RENESAS TECHNICAL UPDATE

Product Category	MPU/MCU	Document No.	TN-RX*-A0281A/E	Rev.	1.00
Title	Errata Regarding Setting of the RCR4.RCKSEL Bit for the RX671 Group MCU		Information Category	Technical Notification	
Applicable Product	RX671 Group	Lot No.	Reference Document	RX671 Group User's Manual: Hardware Rev.1.10 (R01UH0899EJ0110)	
		All

Figure 9.15 Example Flowchart of Initialization when the Sub-Clock is to be Used as the Source to Drive Counting by the Realtime Clock

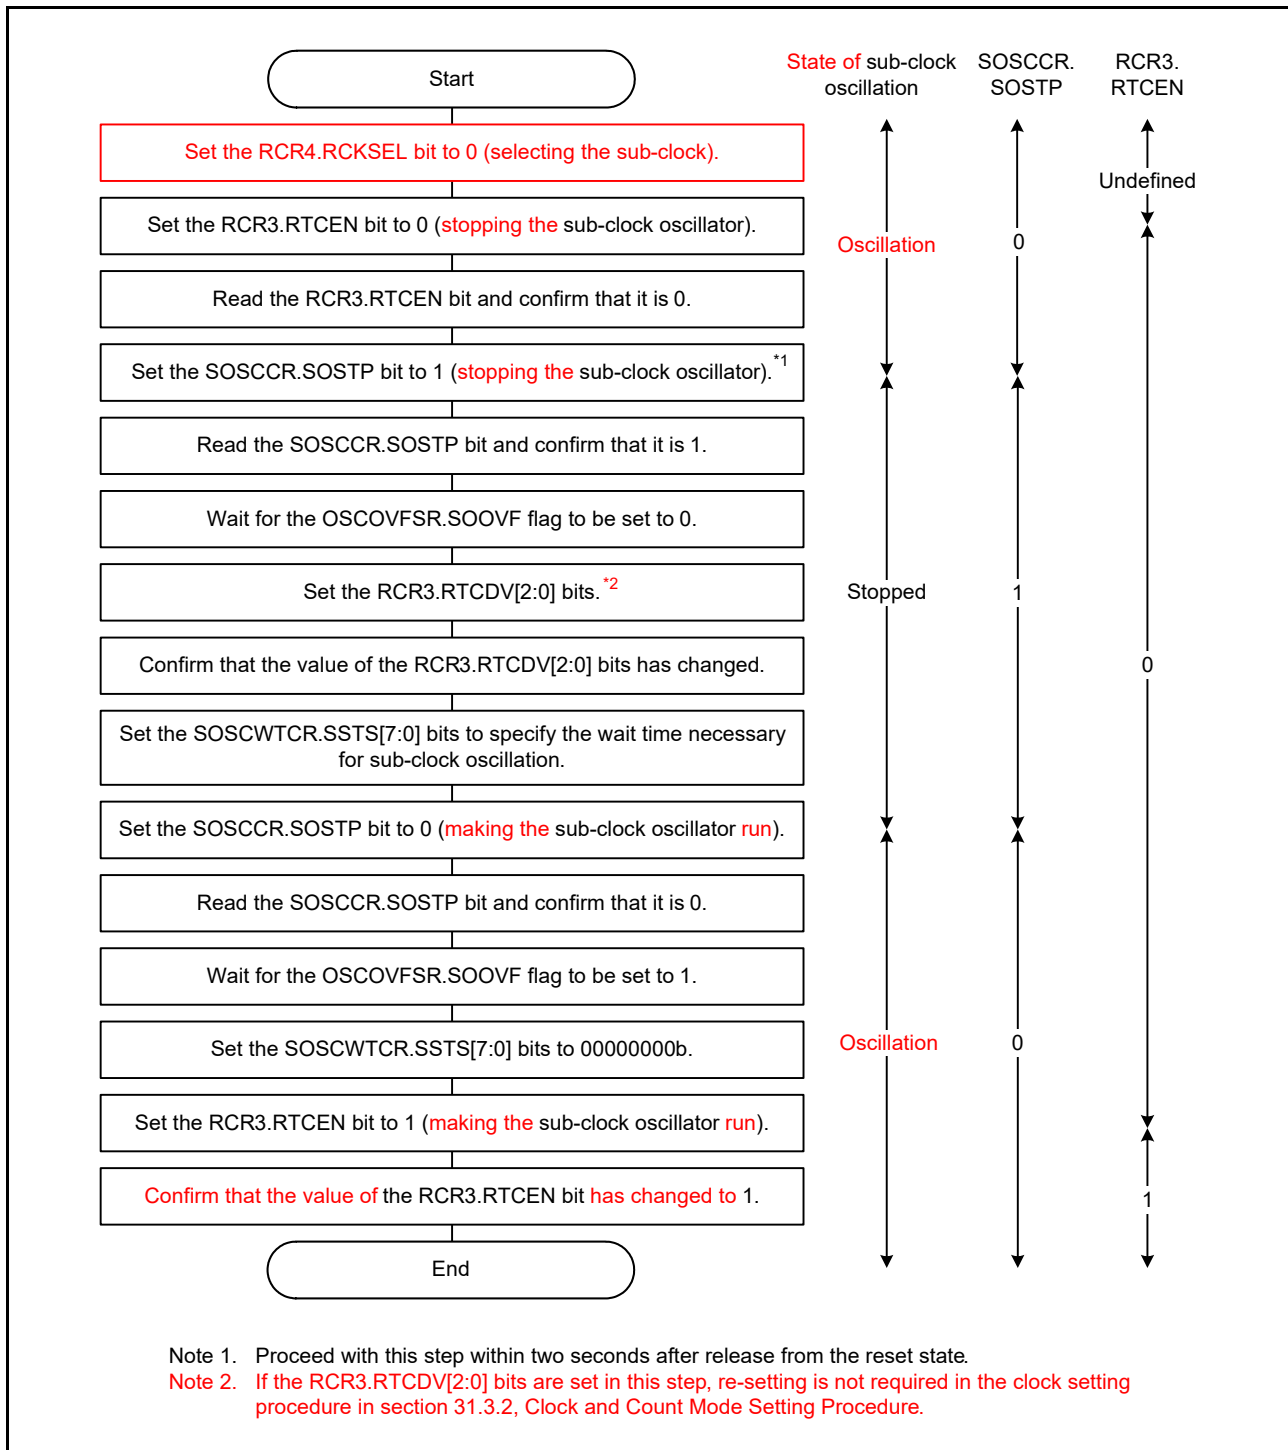
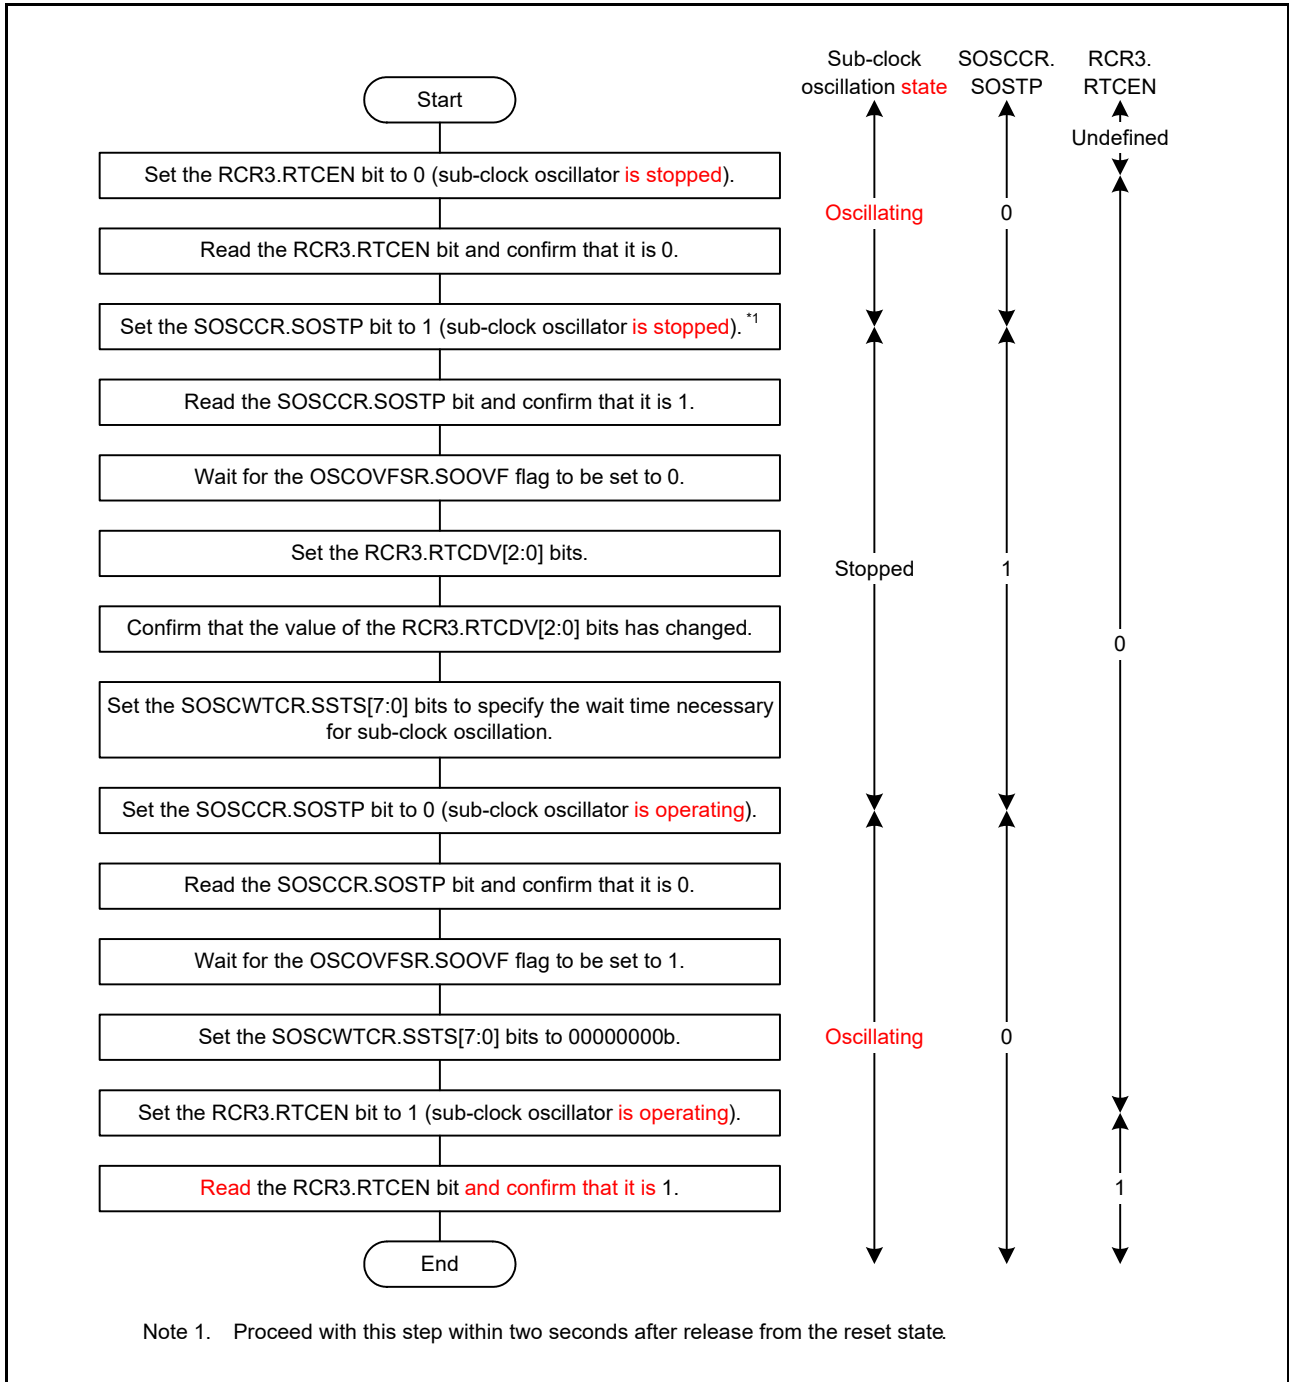
The following deletions are made in Figure 9.15, Example Flowchart of Initialization when the Sub-Clock is to be Used as the Source to Drive Counting by the Realtime Clock.

- The RCR4.RCKSEL bit setting
- Note 2

The title of Figure 9.15 is also modified.

Figure 9.16 Example Flowchart for Initialization when the Sub-Clock is to be Used only as the System Clock

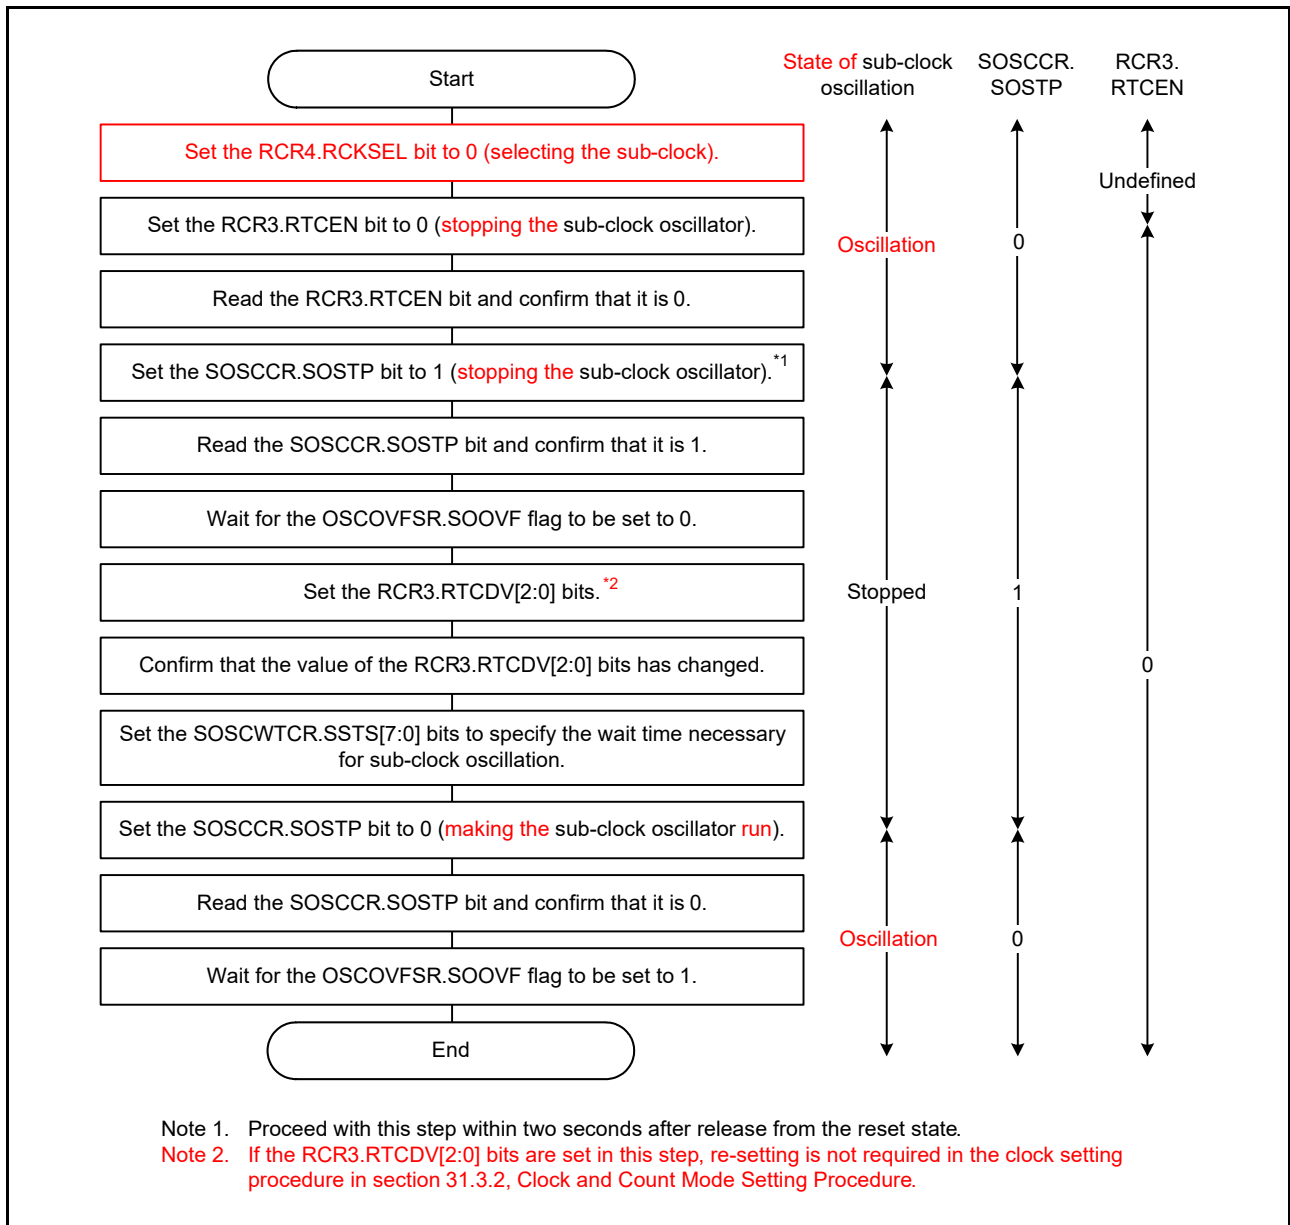
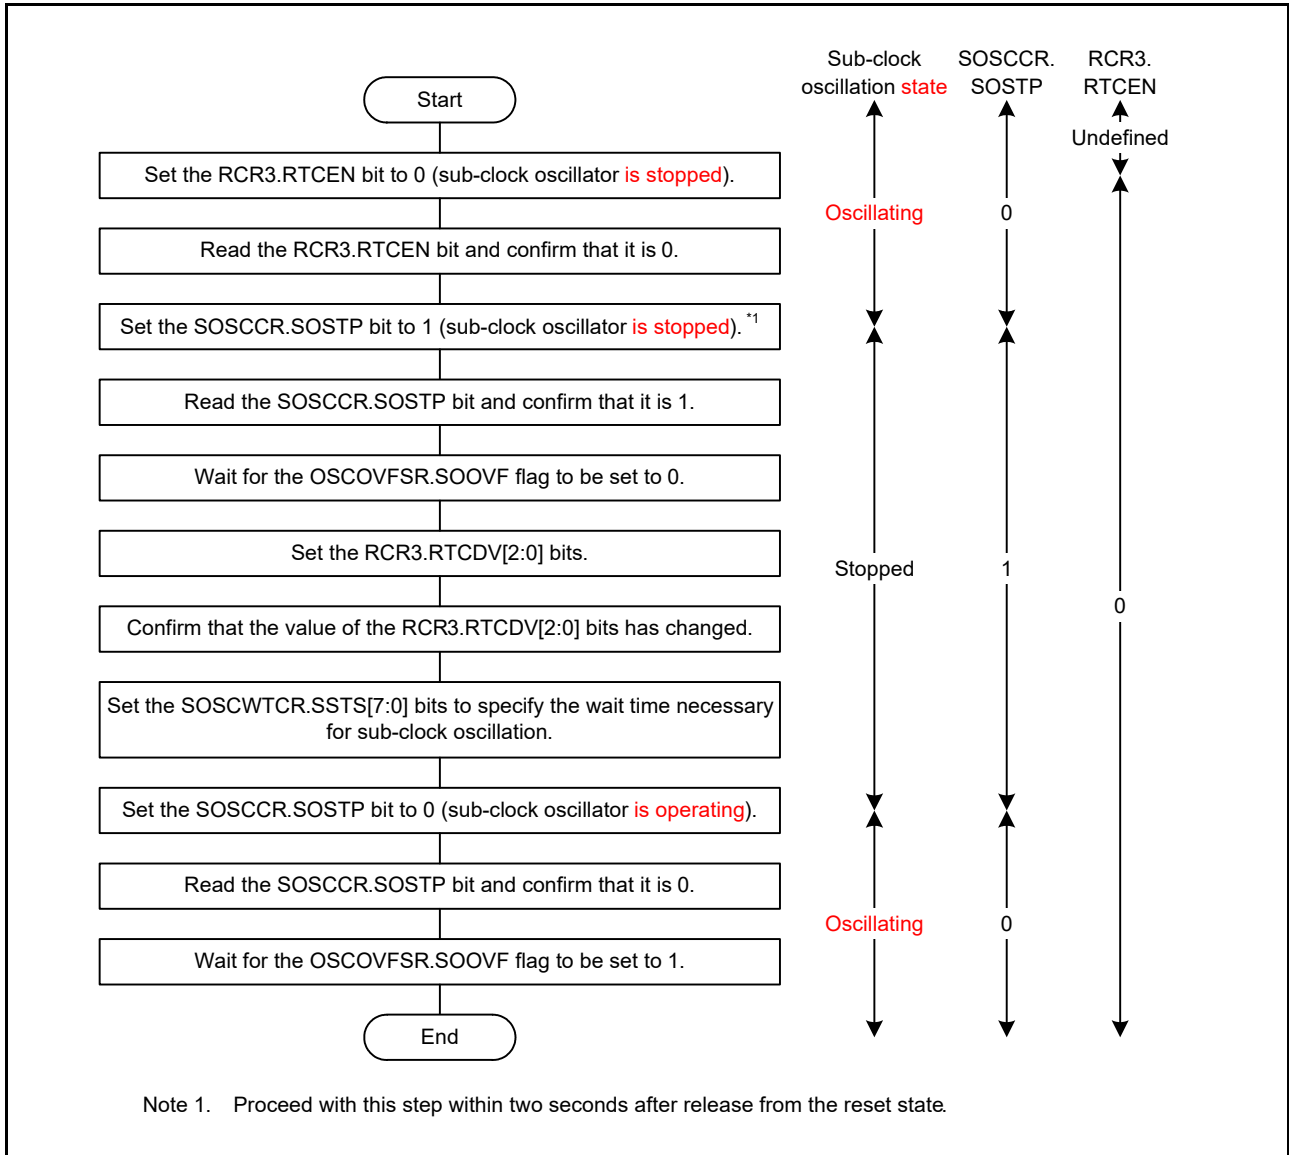
The following deletions are made in Figure 9.16, Example Flowchart for Initialization when the Sub-Clock is to be Used only as the System Clock.

- The RCR4.RCKSEL bit setting
- Note 2

The title of Figure 9.16 is also modified.

Figure 9.17 Example Flowchart for when the Sub-Clock is not to be Used

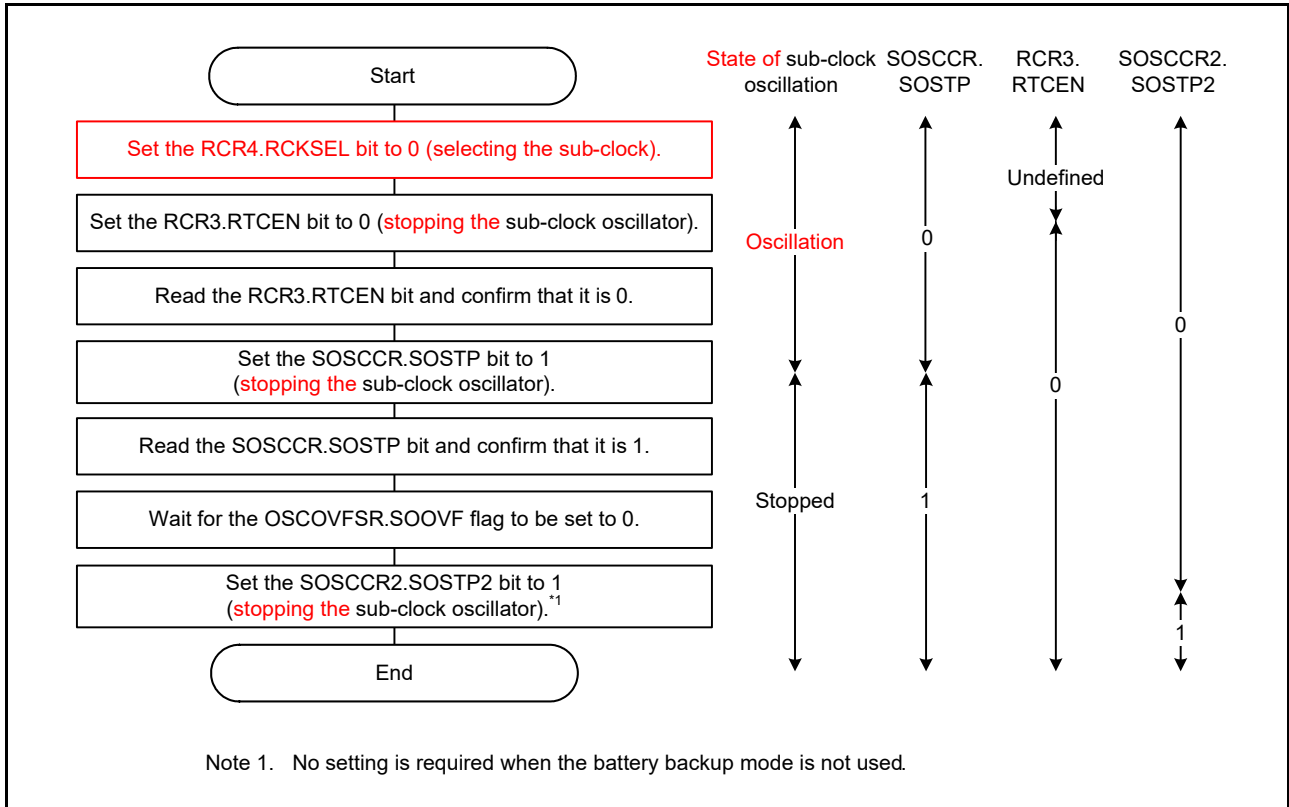
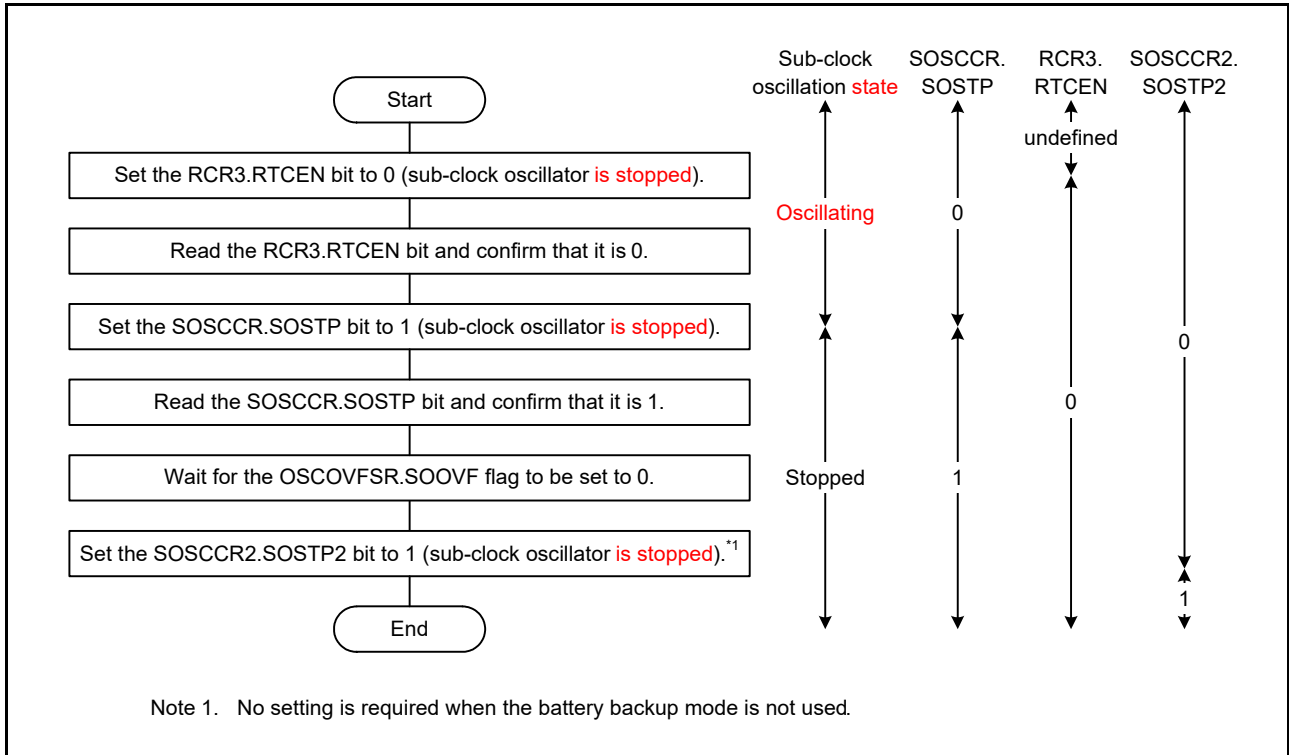
The following deletion is made in Figure 9.17, Example Flowchart for when the Sub-Clock is not to be Used.

- The RCR4.RCKSEL bit setting
